Access Compliance Report

Public Rights-of-Way

(Pedestrian Signals)

Intersection ID: N/A	Main Street:	Cross Street: N/A	Location: N/A
ADA ID: E819162B7CDA	Signal Type: One Push Button-Non APS	Overall Compliance: No	Severity Score: BTN 1: N/A BTN 2: N/A No BTN: N/A
Codes/Mitigation Info/Possible Solution		Field Measurements/Component Compliance

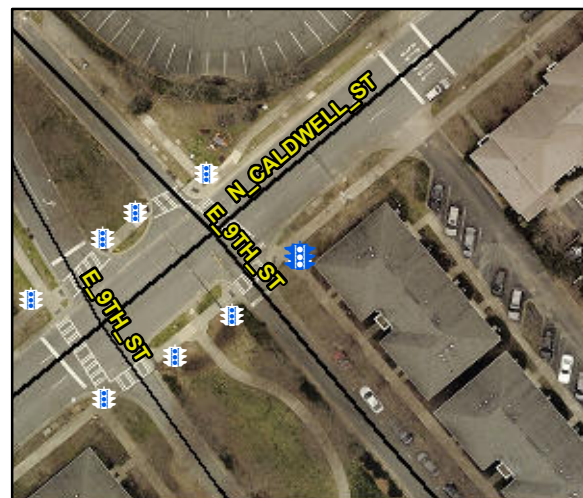
Surveyor Notes: TEXT HT 5/16

PROW/ADA: R410.6, TMUTCD 4e.08, R406.2

Possible Solutions: Replace Signal Push Button With APS Button on New Post. Remove & Replace Sign.
